Response to request for information memo

Tilbuster Solar Farm

February 2022

Project Number: 20-729

Figure 4-2 'No impact zones' north

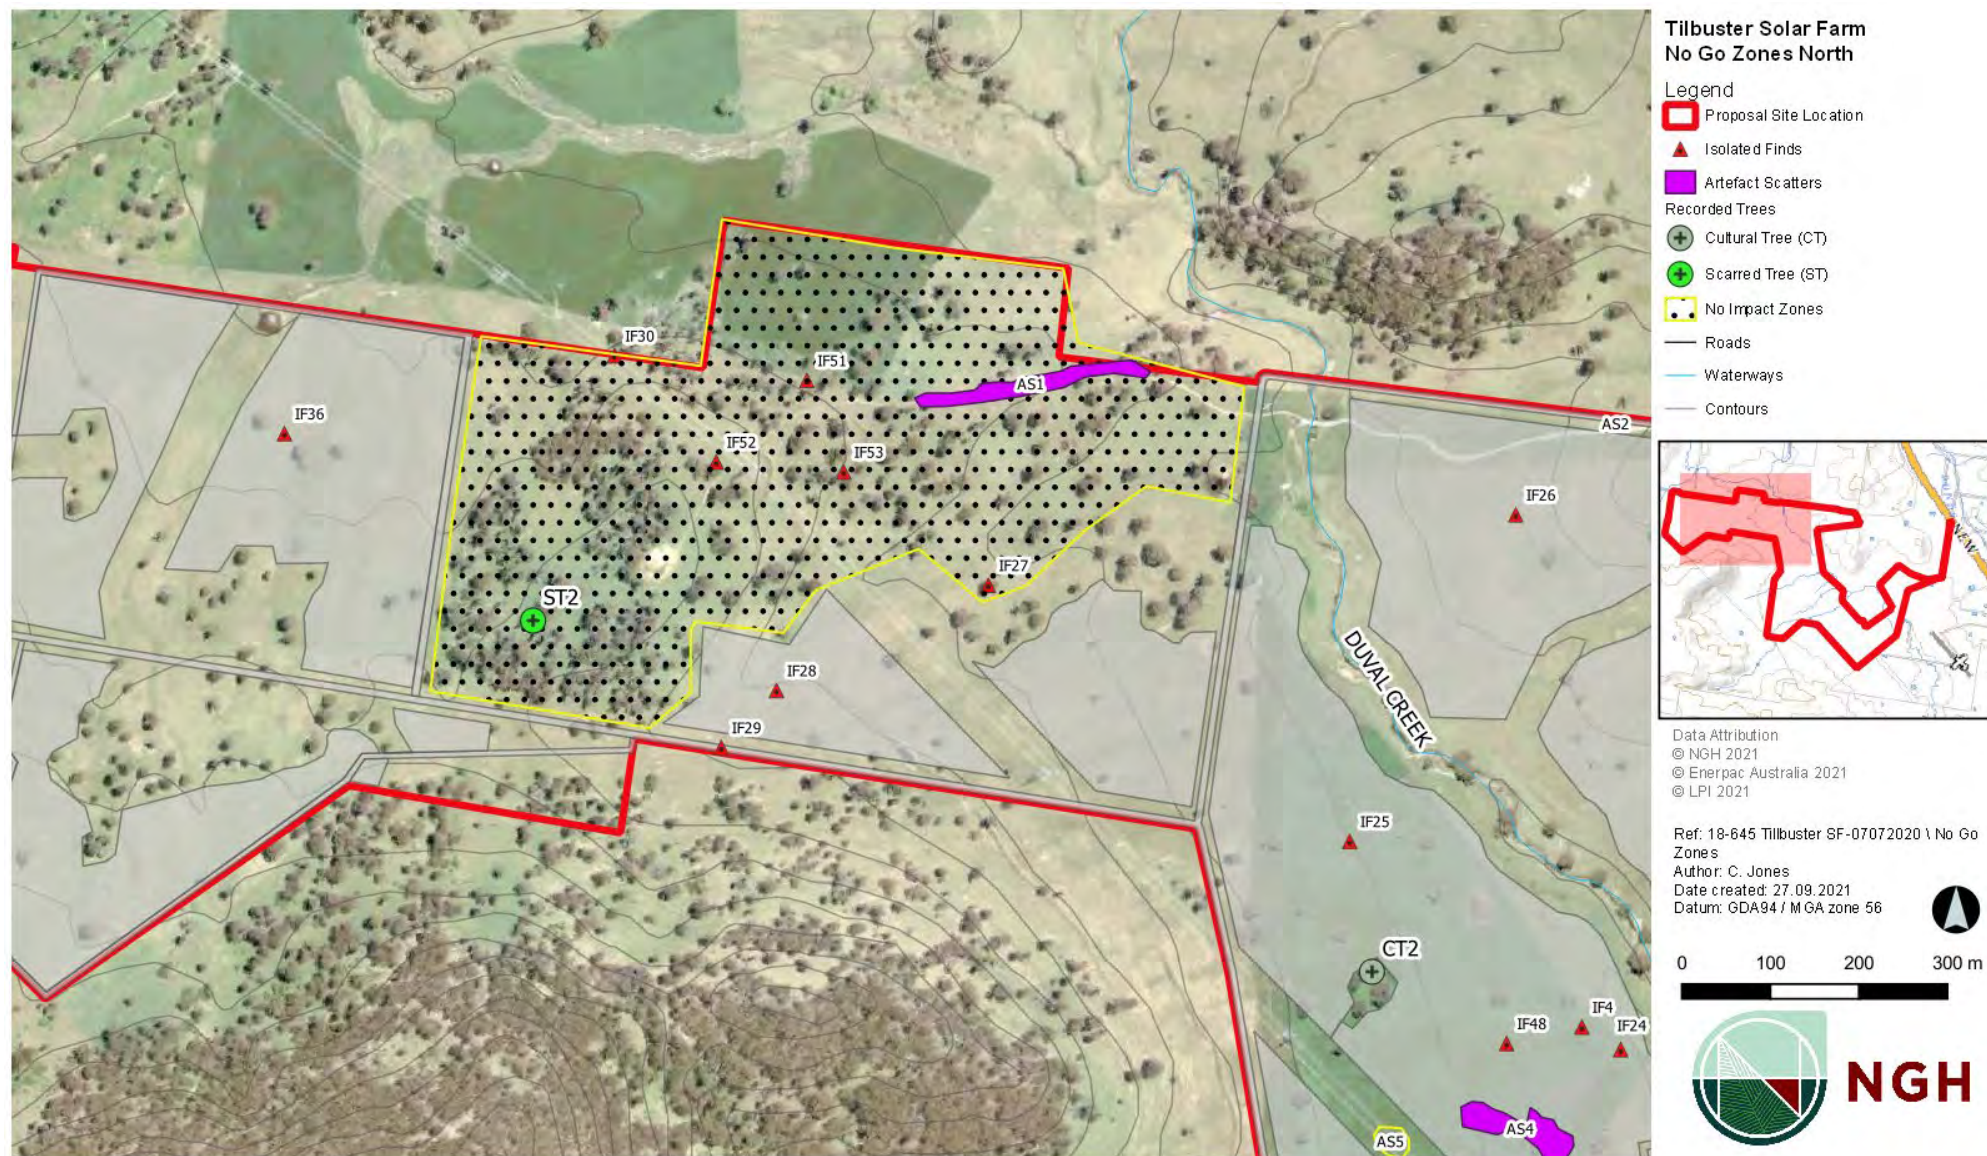
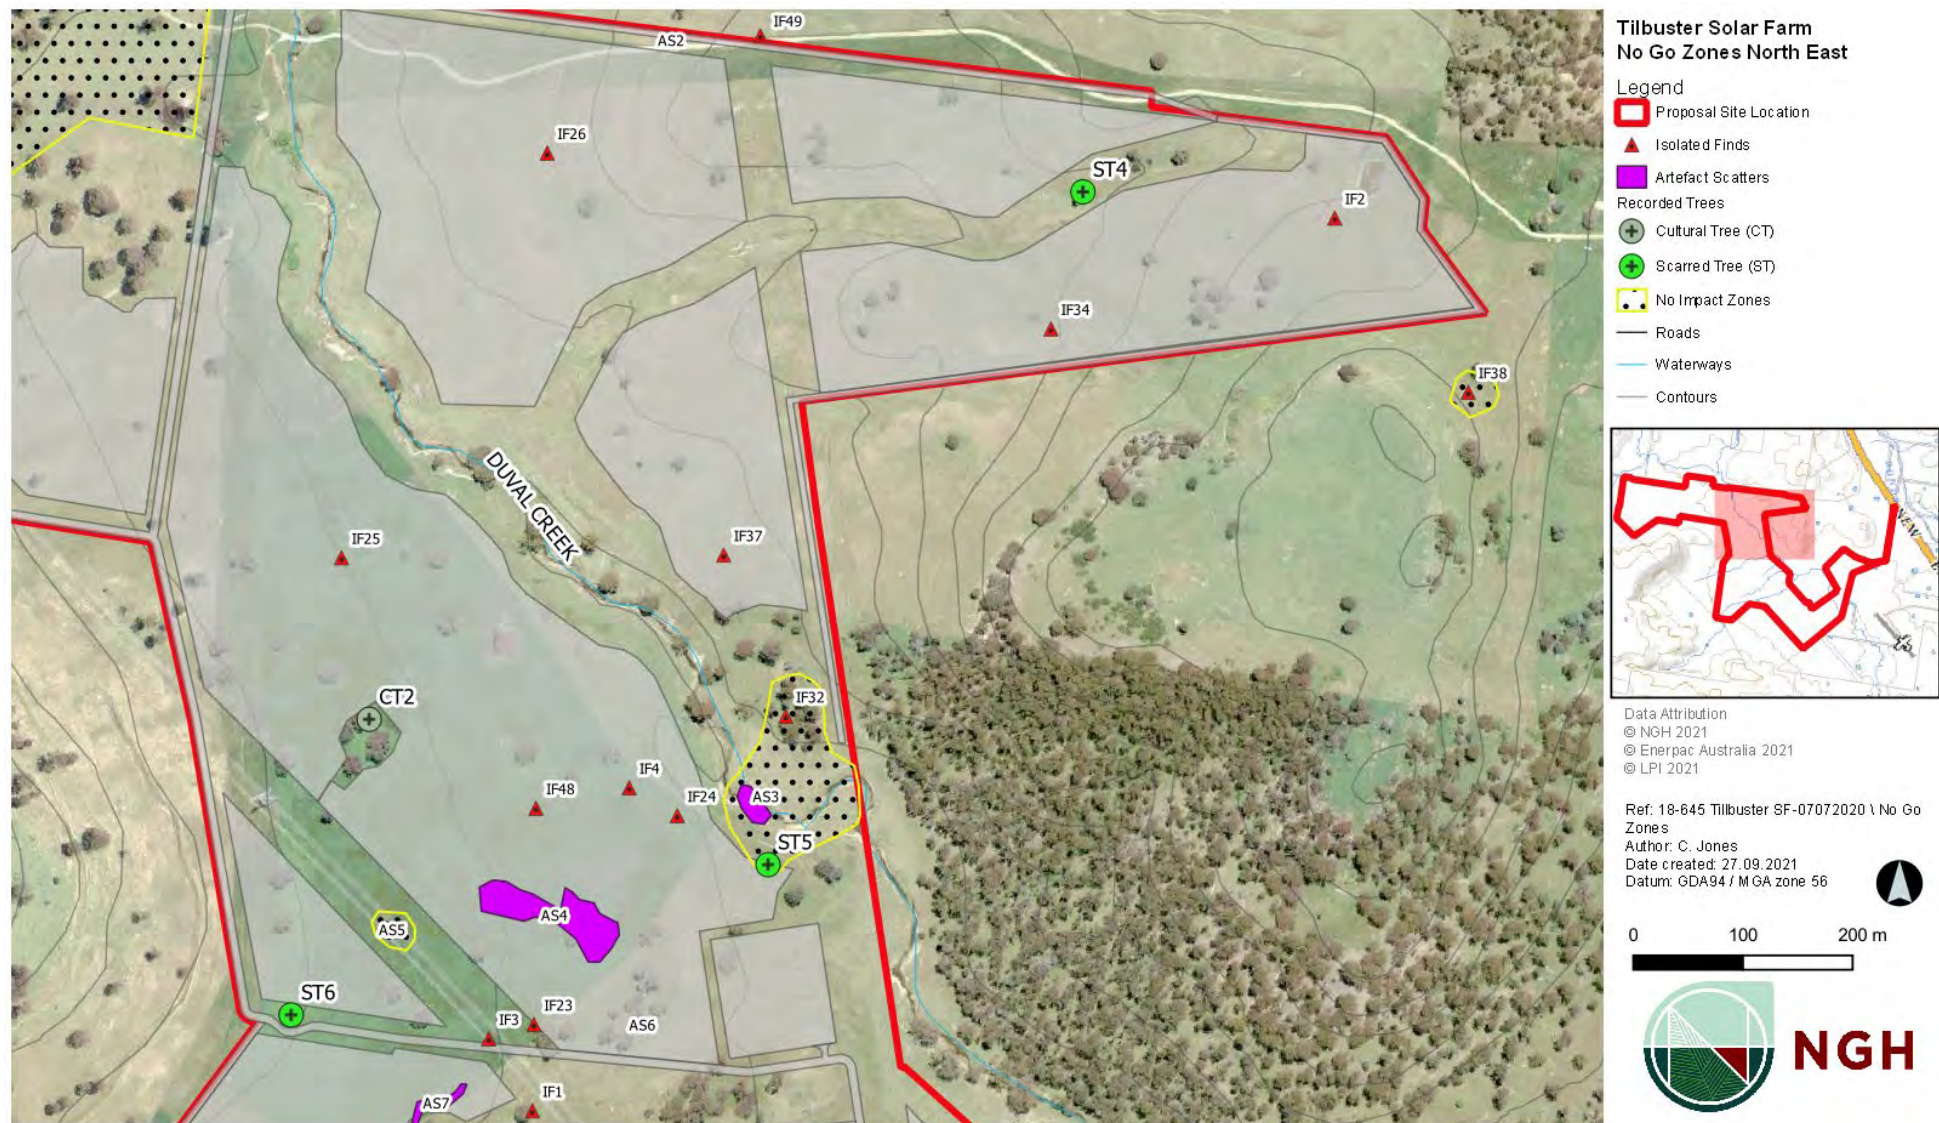
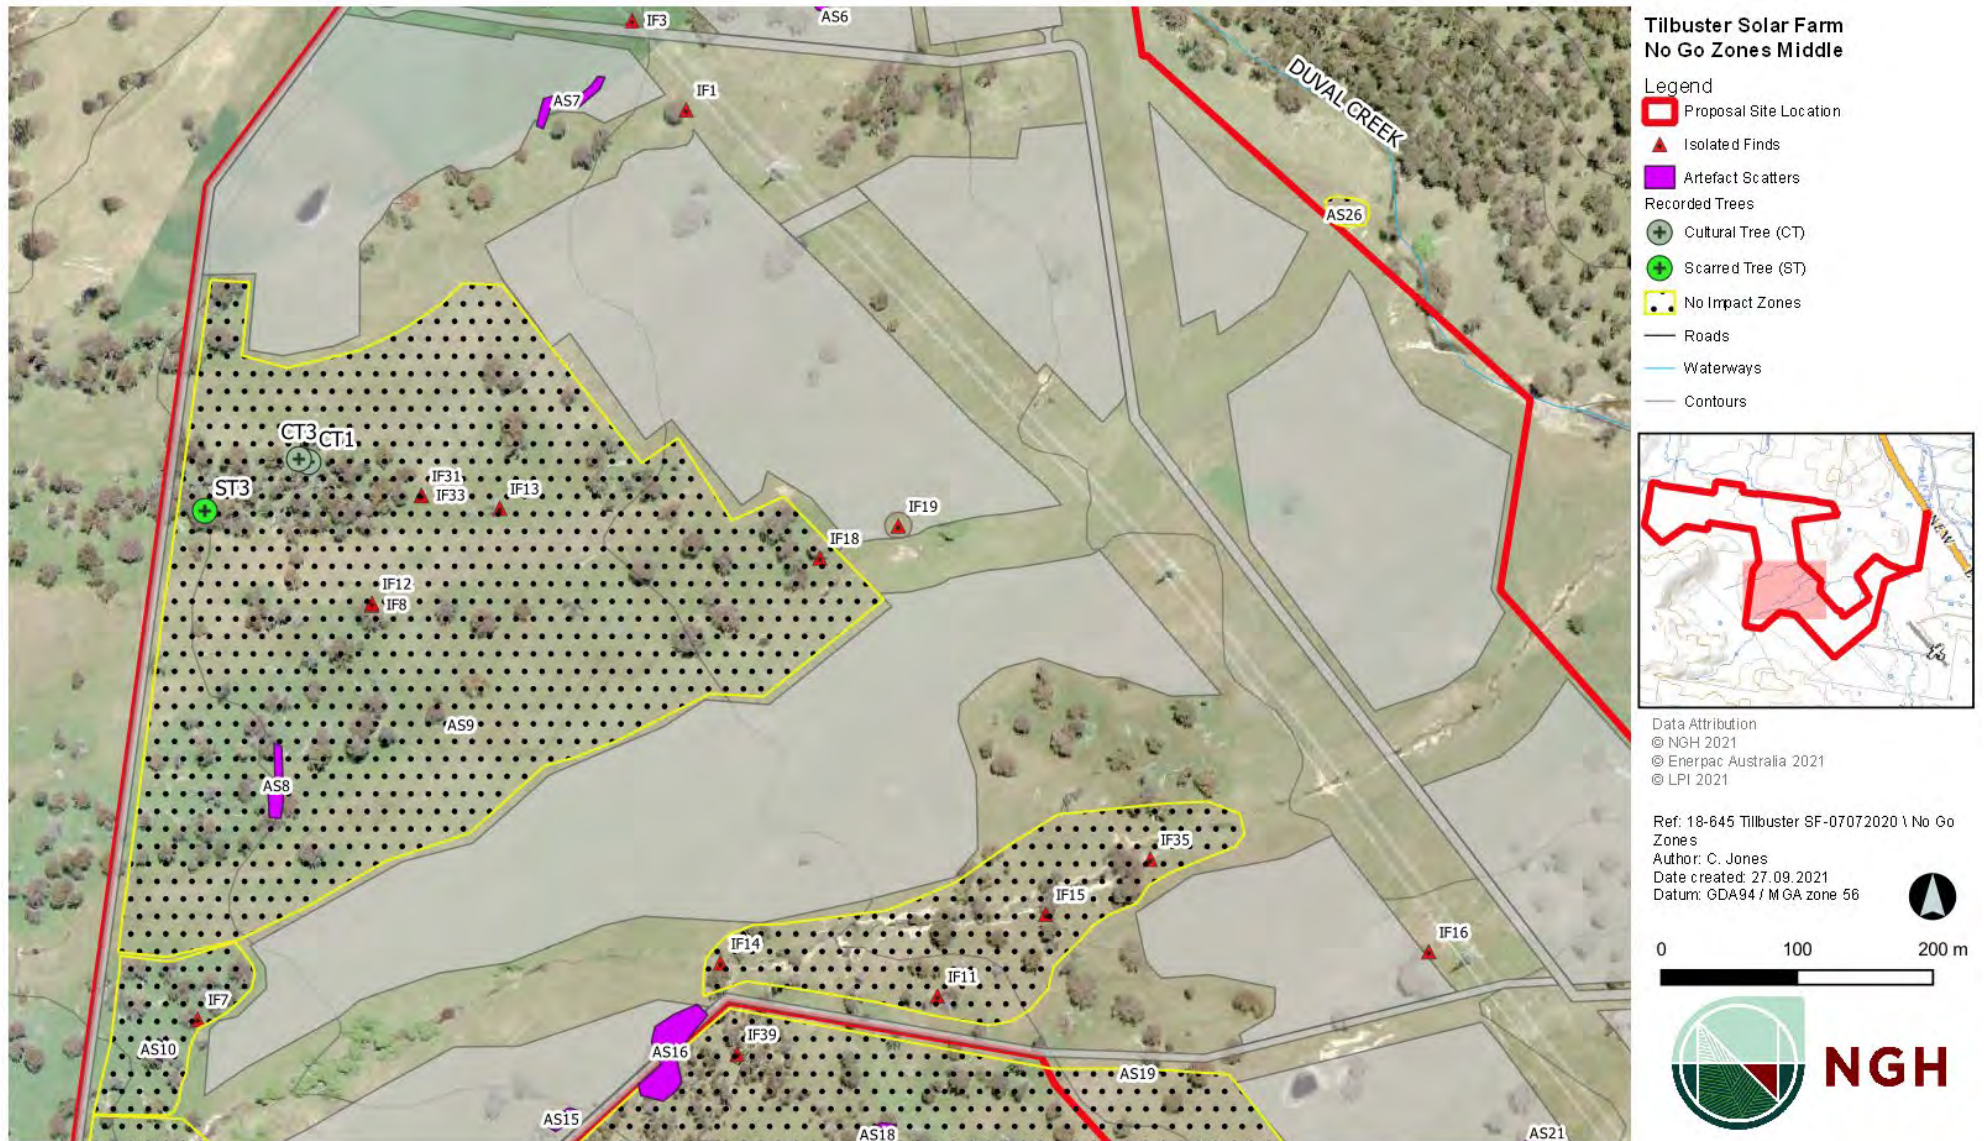
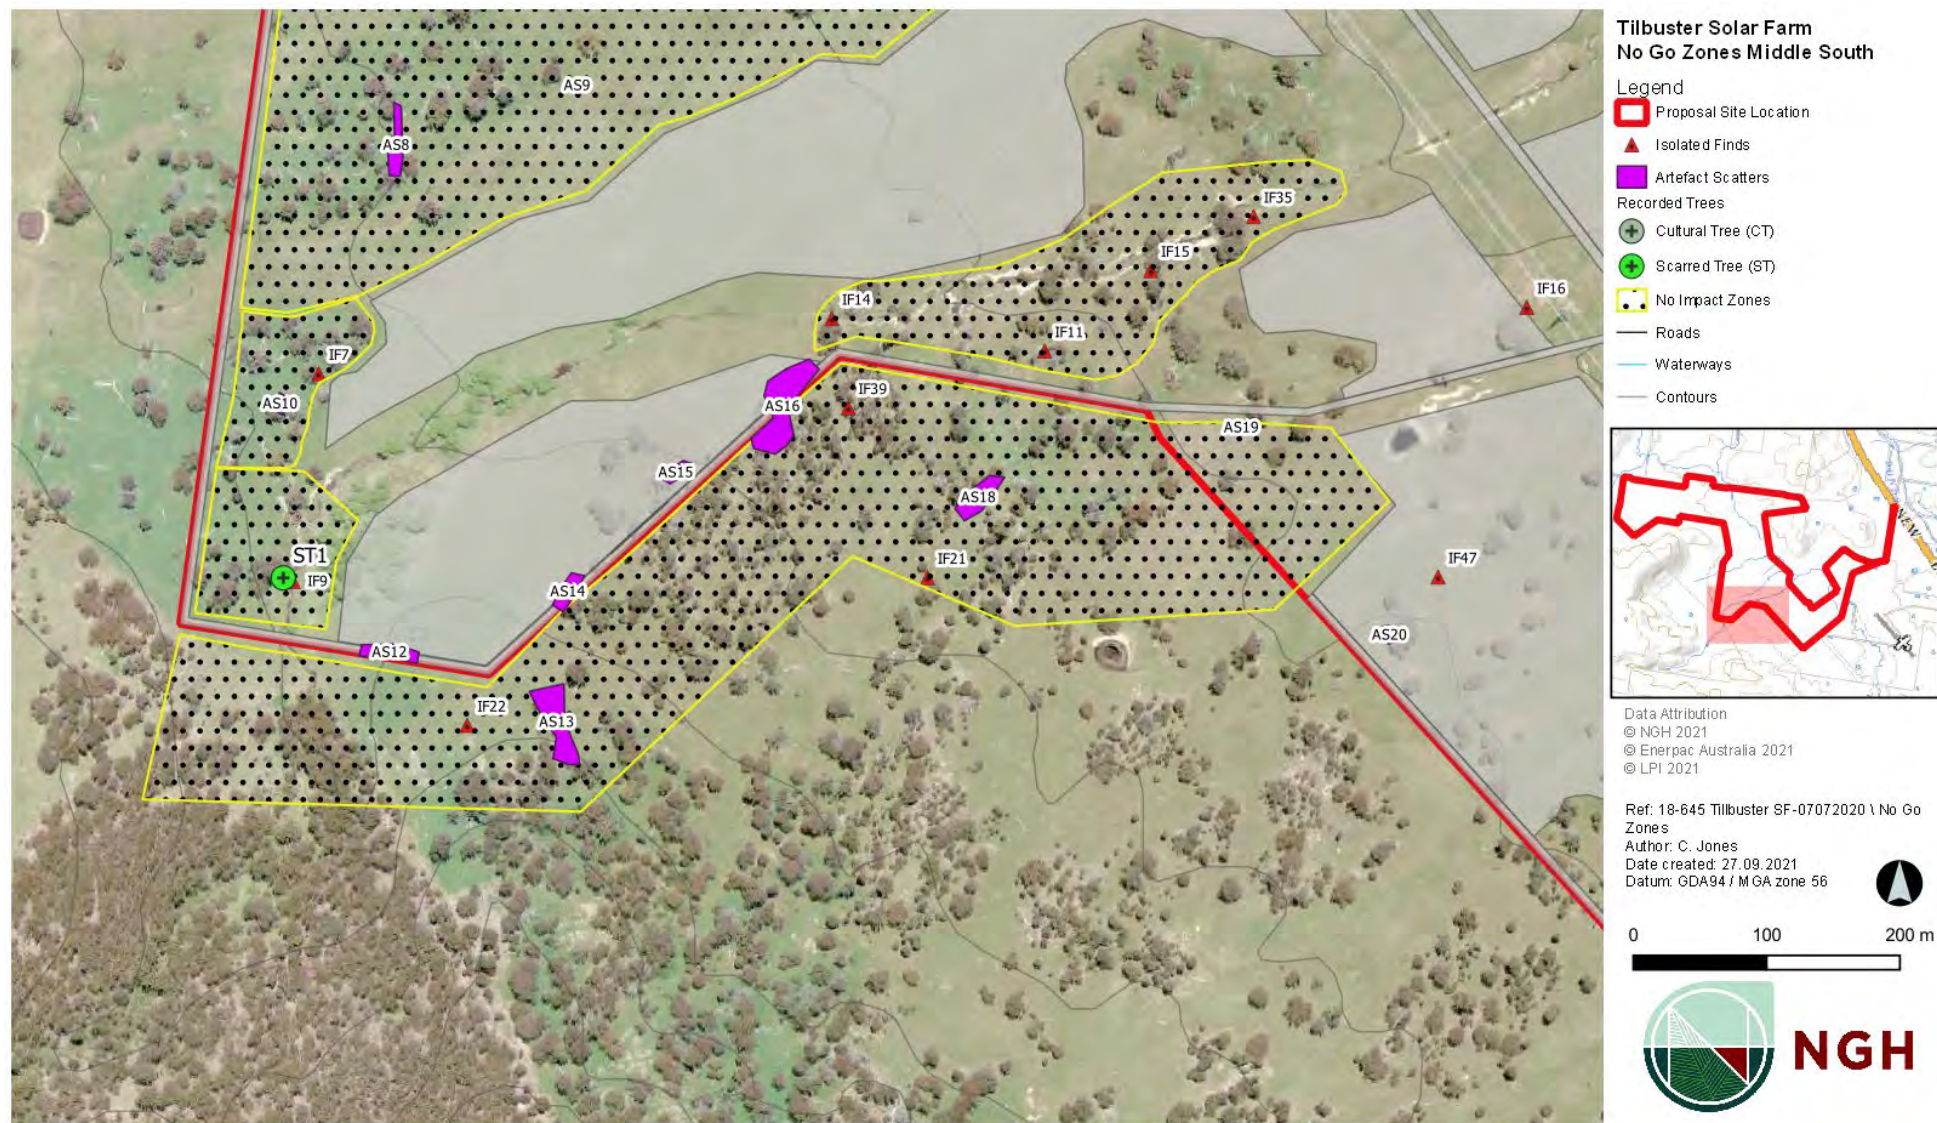
1. Refer to the latest VPA offer between Enerparc and Council.
2. Aboriginal Heritage:
 - Clarification regarding the indirect harm to some scar/cultural trees has not been provided. Heritage NSW opposes any harm to any culturally modified or culturally significant trees.

2. There are 15 'no impact zones' within the Development Site as shown in Figure 4-2 to Figure 4-6. These must be fenced or otherwise clearly delineated and included in all onsite inductions and management plans. The development should avoid any direct or indirect impacts to the sites located within these 'no impact zones'.
